ACCESS REPORT

Indoor Bouldering
Development Application Phase
Alterations and additions – change of use
144 Old Pittwater Road, Brookvale

Prepared for
Skywood Climbing

Reference No.
25058

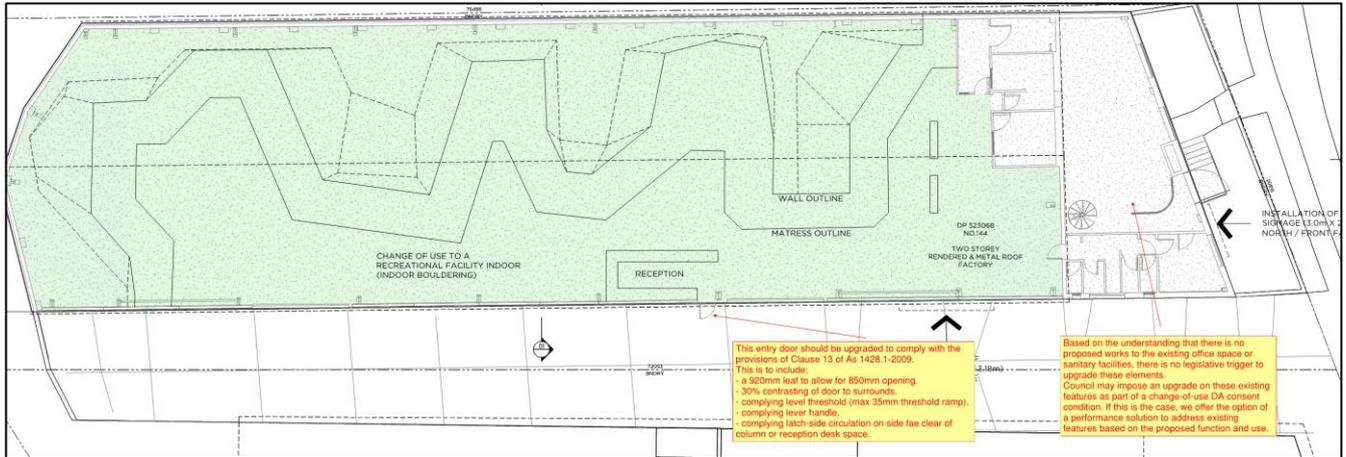
This entry door should be upgraded to comply with the provisions of Clause 13 of As 1428.1-2009. This is to include:

- a 520mm leaf to allow for 850mm opening
- 30% contrasting of door to surrounds
- complying level threshold (max 35mm threshold ramp)
- complying lever handle
- complying latch-side circulation on side face clear of column or reception desk space.

Based on the understanding that there is no proposed works to the existing office space or sanitary facilities, there is no legislative trigger to upgrade these elements. Council may impose an upgrade on these existing features as part of a change-of-use DA consent condition. If this is the case, we offer the option of a performance solution to address existing features based on the proposed function and use.
